Documentation Description: Nonconformance Report - C-01006

# NONCONFORMANCE REPORT

C-01006

Watertight doors & frames

Door # 88 (C)

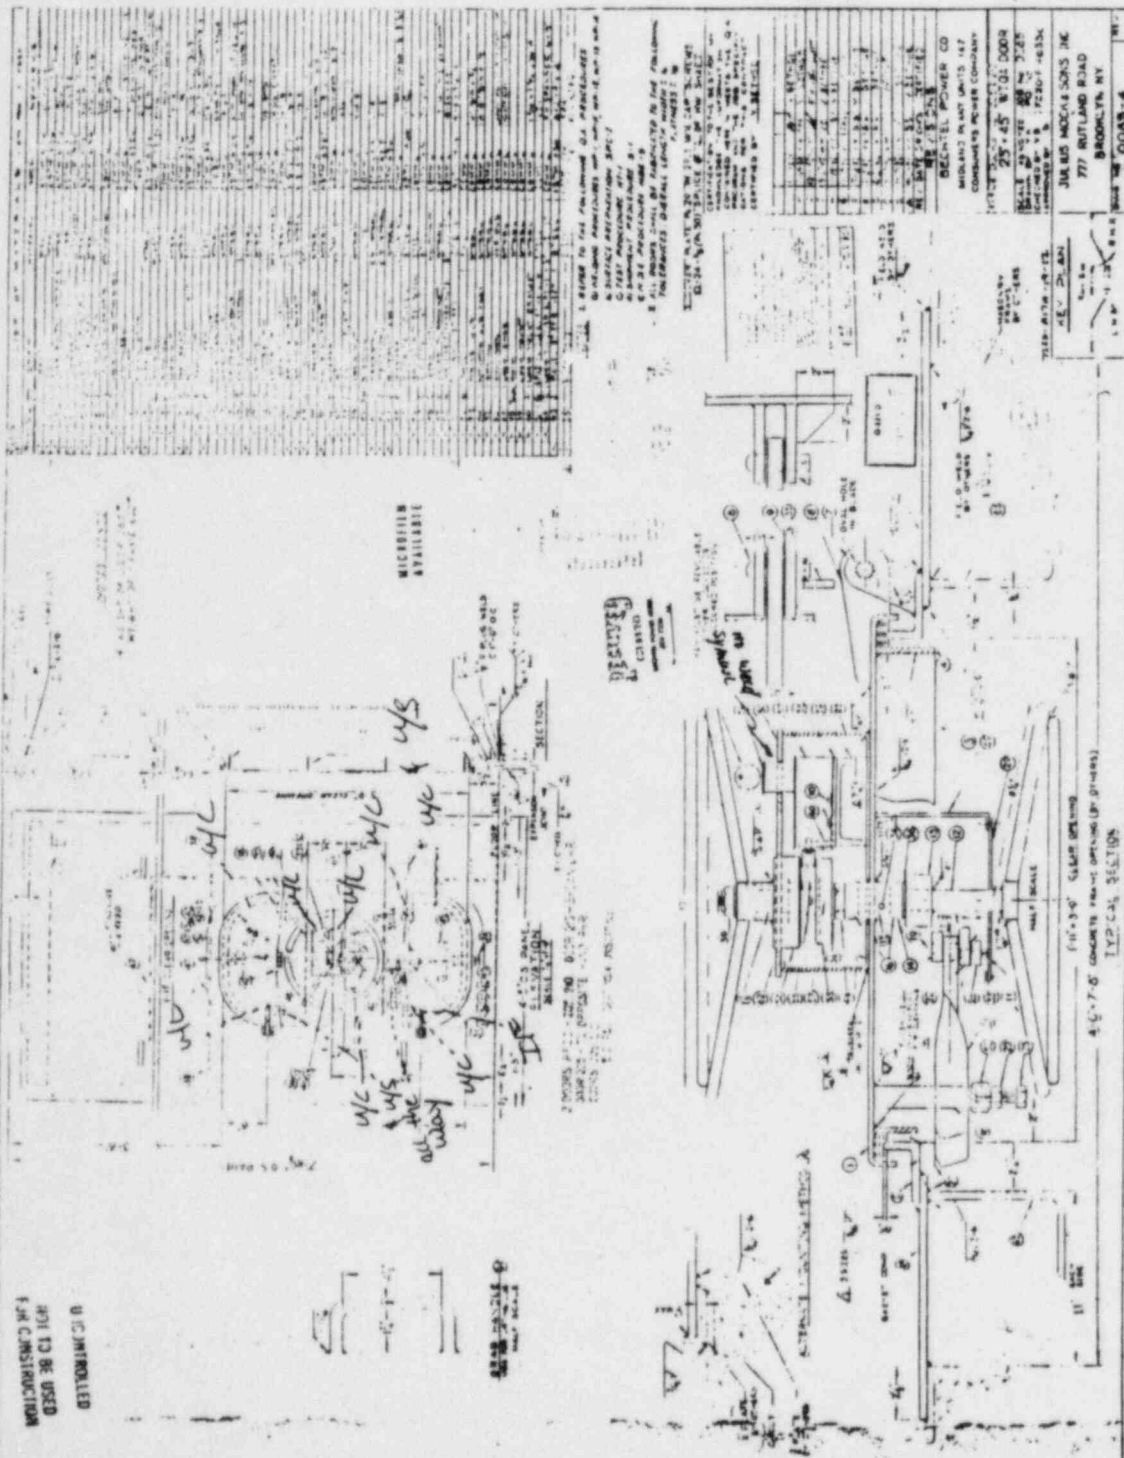
Pages 6 thru 36  
 are just  
 reference copies.  
 The big prints  
 are in QC Vault.

Doc # 109  
C

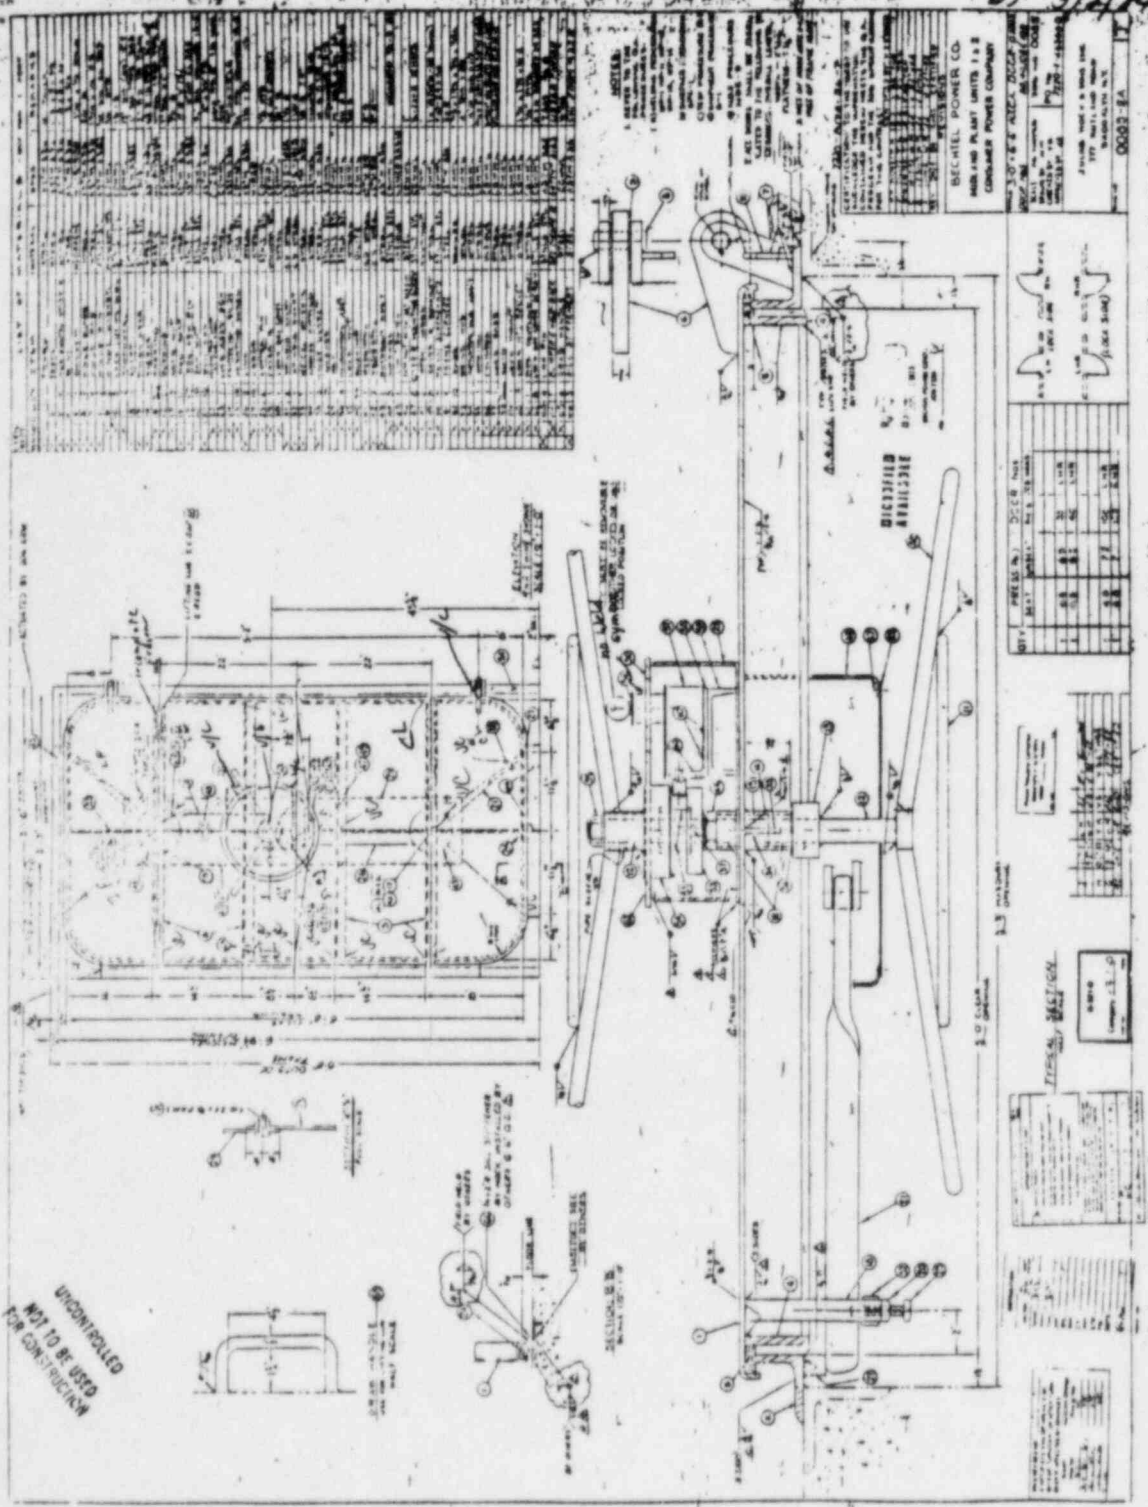
T.F. = incomplete fusion  
C.L. = cold lap  
slag = slag  
4/c = undercut  
4/5 = under size

Door # 53

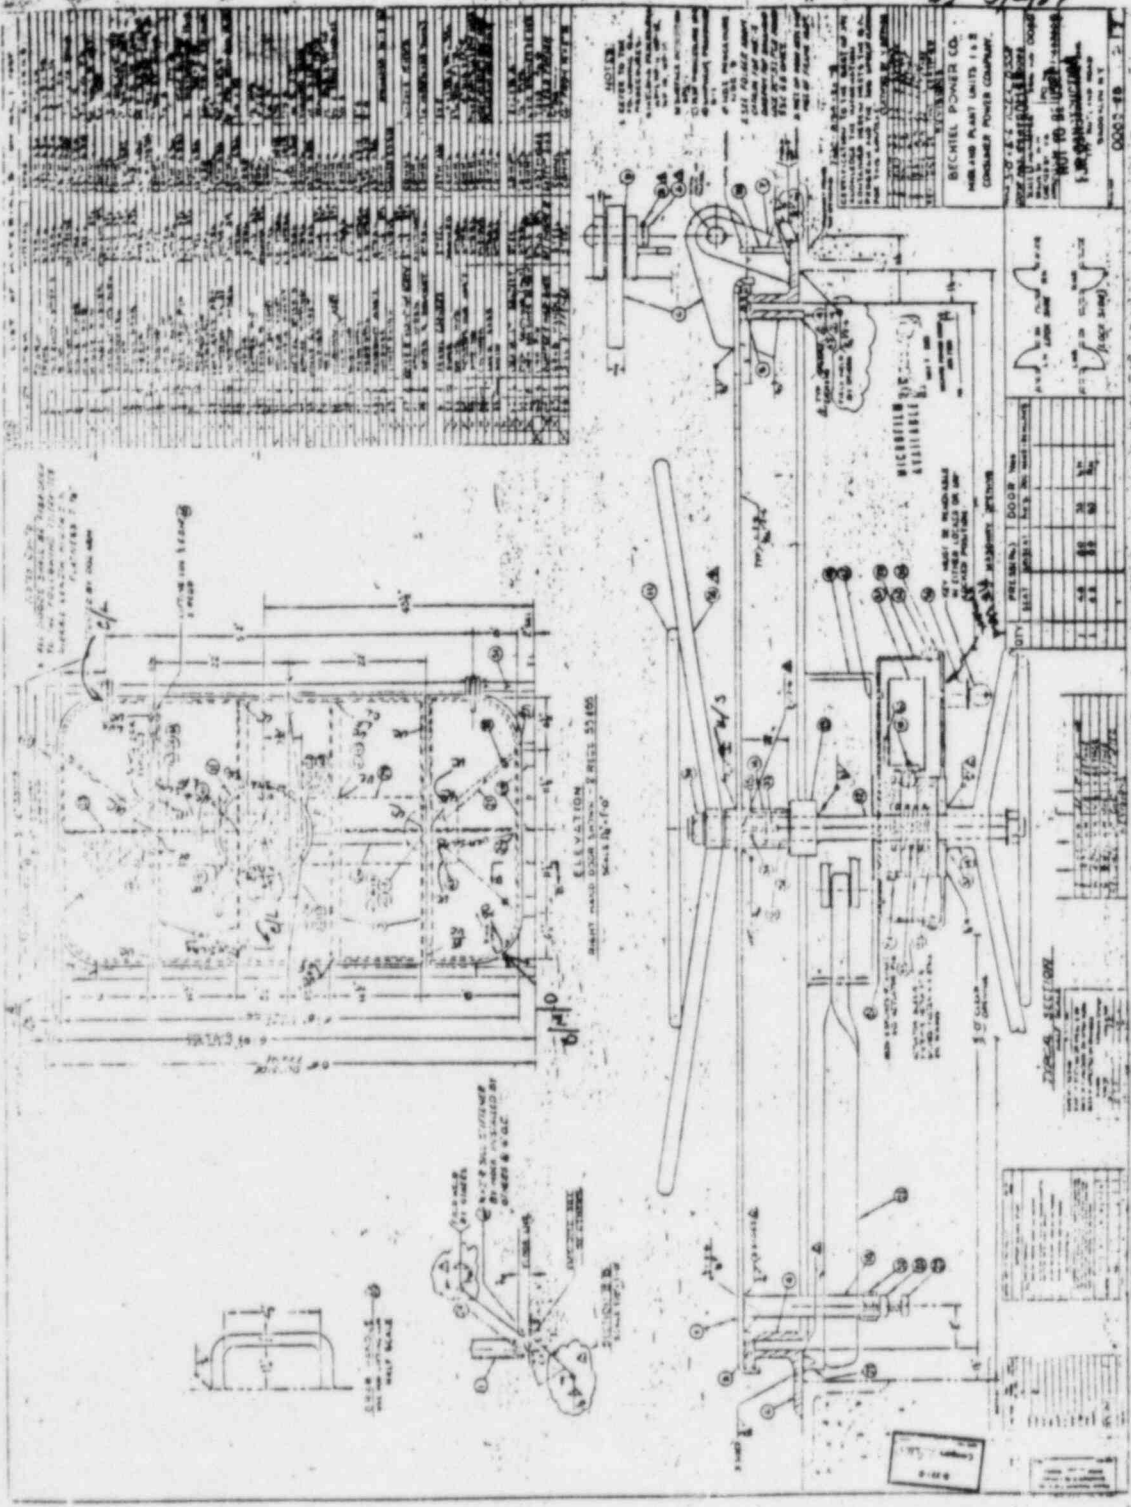
C.L. = Cold Lap  
 P.D. = Porosity  
 L.F. = Lack of Fusion  
 W.C. = Undercut  
 W.S. = Underfill

Req # 108

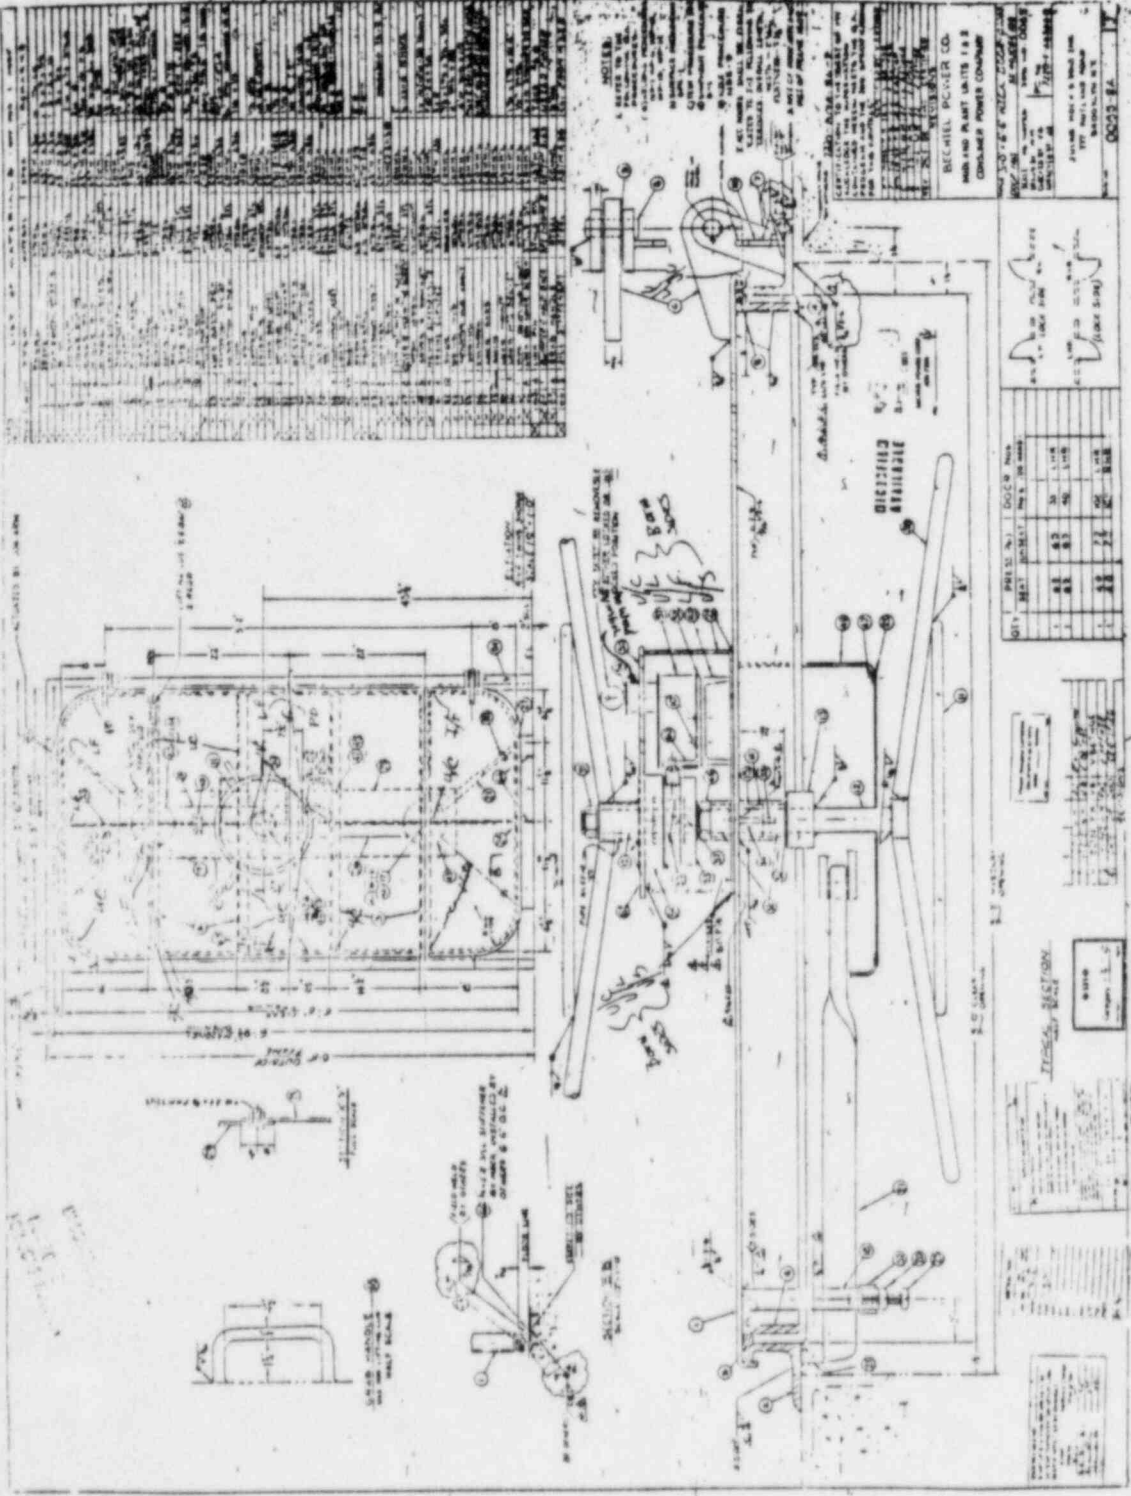
WC = undercut  
 WS = under size  
 WL = under length

Door #77 ©

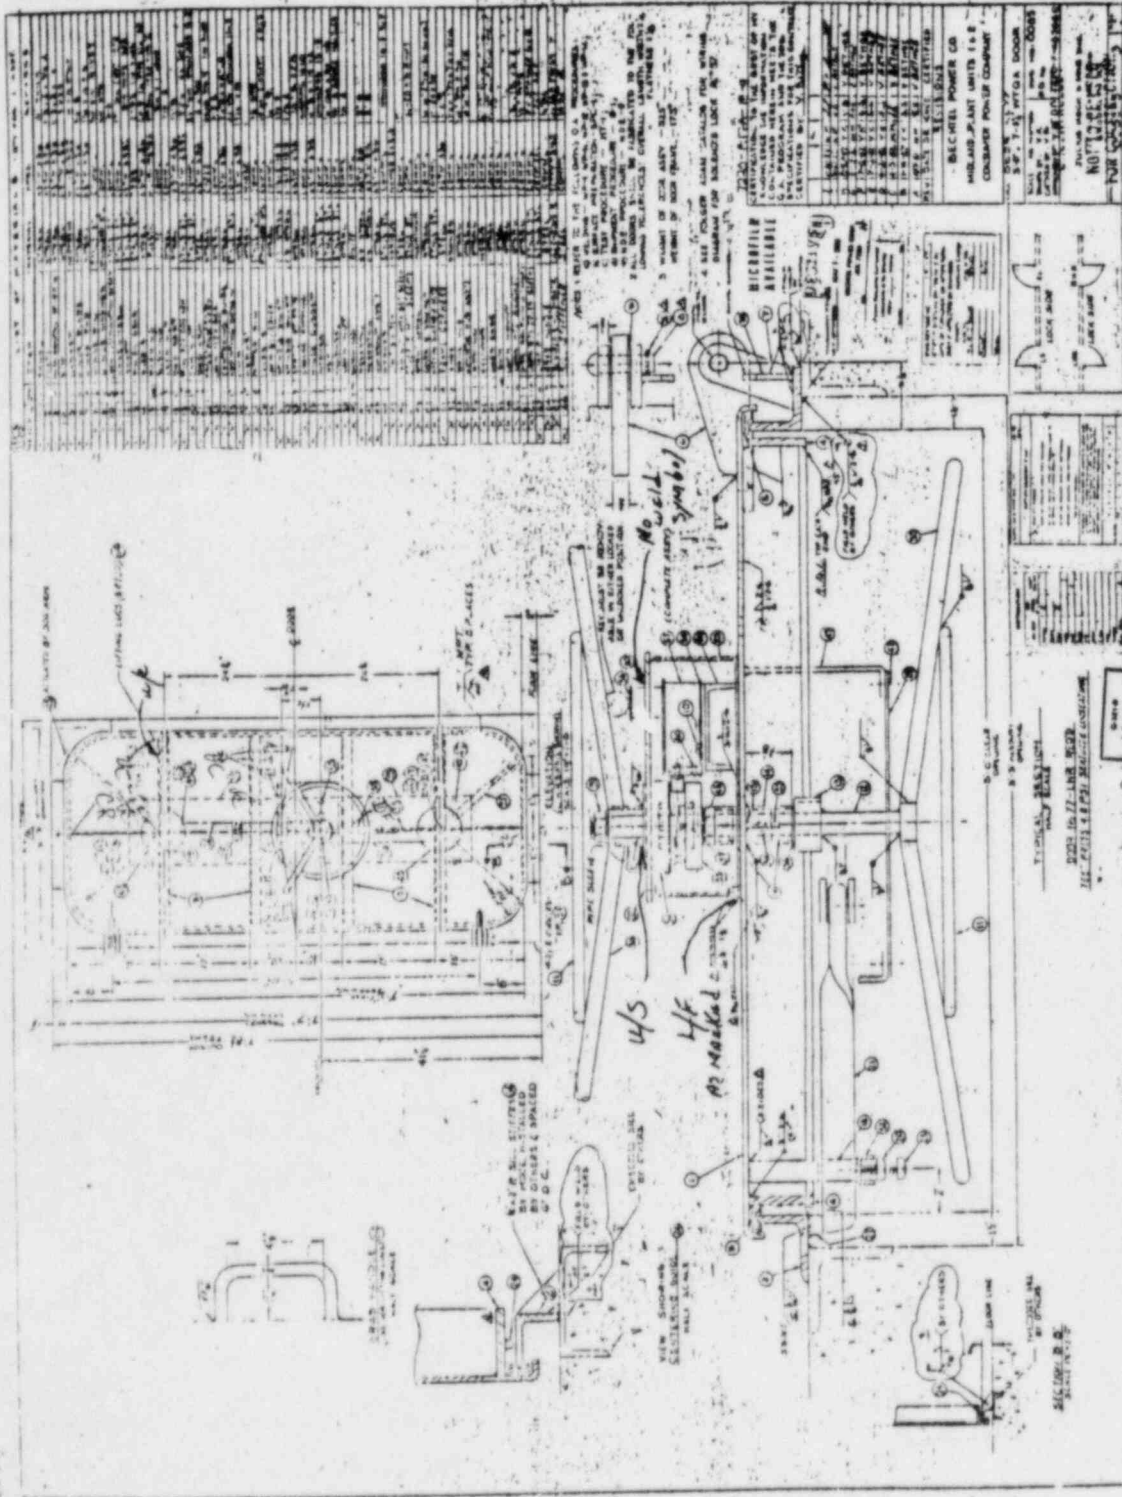
C.R. = cold roll  
 L/F = lack of fusion  
 C/L = undercut  
 W/S = under size
